Item 3.**Development Application - 45-47 Crown Street, Woolloomooloo - D/2019/832****File No.:** D/2019/832**Summary****Date of Submission:** 2 August 2019**Applicant:** Christopher Jordan**Architect/Designer:** Christopher Jordan Architecture and Design**Owner:** Maria Parison**Cost of Works:** \$880,000.00**Zoning:** B4 - Mixed Use Zone

Summary Recommendation: This proposal is recommended for refusal.

Figure 10: Proposed third floor / roof plan

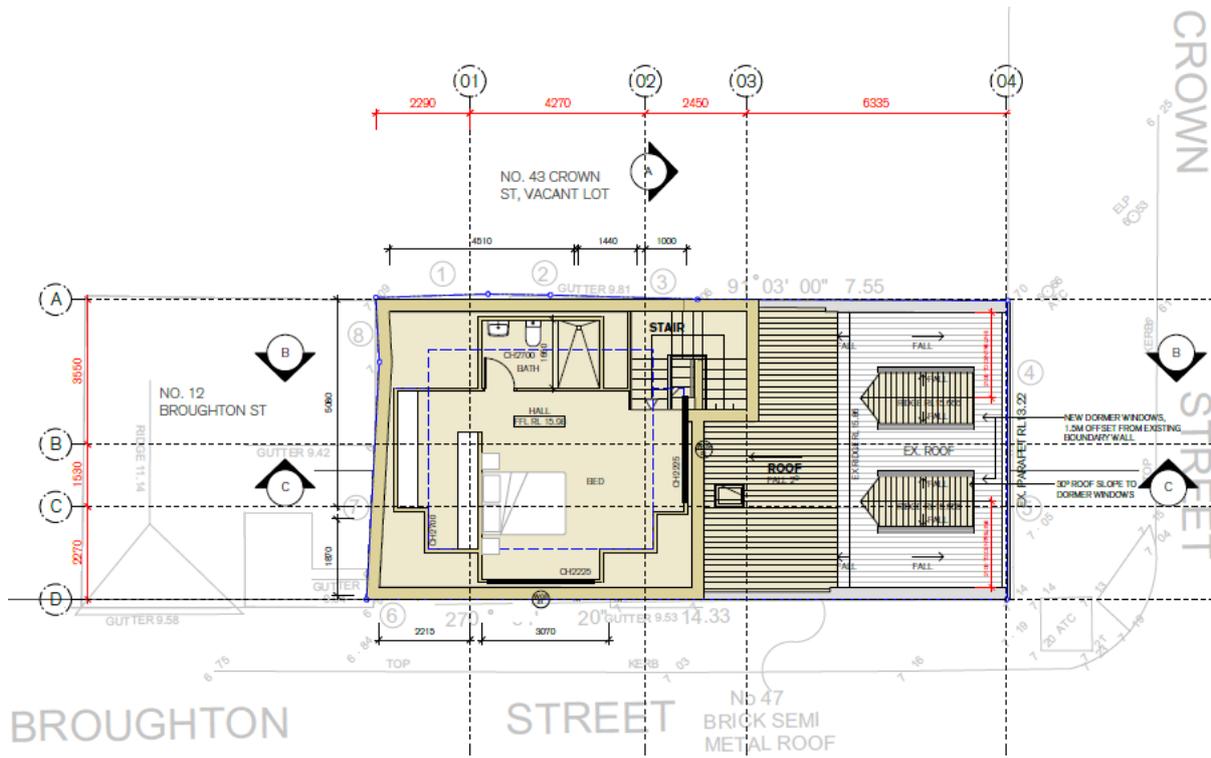
30. The applicant states that the proposed infill building presents as 3 storeys with a mansard roof and therefore represents development contemplated by the height in storeys control.

31. This additional attic level provision allowed under the LEP relates to the conversion of more traditional pitched roof rooms such as those of the existing terraces. The proposed mansard is uncharacteristic of the conservation area and has a flat roof with a very limited mansard pitch which therefore presents as an additional floor.

32. Moreover, the proposed mansard roof/attic level does not meet the definition of an attic set out by the Sydney LEP, being 'a habitable space contained wholly within a roof above the ceiling line of the storey immediately below'. The proposal is non-compliant with this definition due to the central stairwell core which protrudes from the mansard roof.

33. The proposal presents as a 4-storey development which contravenes the 3-storey height control set out in the Sydney DCP.
34. The applicant's assertion that the proposal will contribute to the amenity and revitalisation of the area through the restoration of two existing terraces is not supported. The proposed development will significantly constrain the level of amenity enjoyed by the existing terraces on site by removing existing areas of private open space currently provided by the rear yard areas and blocking solar access to the rear of the property - see further discussion regarding amenity impacts under the Issues section below.

Figure 14: Proposed Section A & Section B

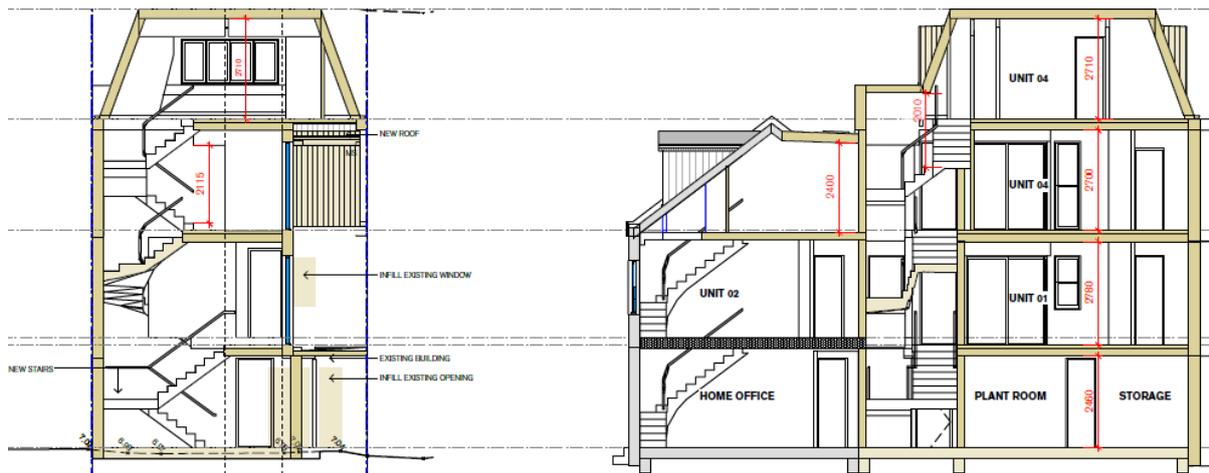
53. The site has a 3 storey height in storeys control pursuant to Section 4.2.1 of Sydney DCP 2012. The proposed infill building presents as four storeys.

54. The proposed infill building is considered to be overbearing and will provide a poor interface between the existing terraces and buildings to the west along Broughton Street. The infill relates poorly to the existing terraces effectively being an extension of, rather than separate to the terraces, and the heritage listed sandstone wall which is poorly integrated into the design of the development.
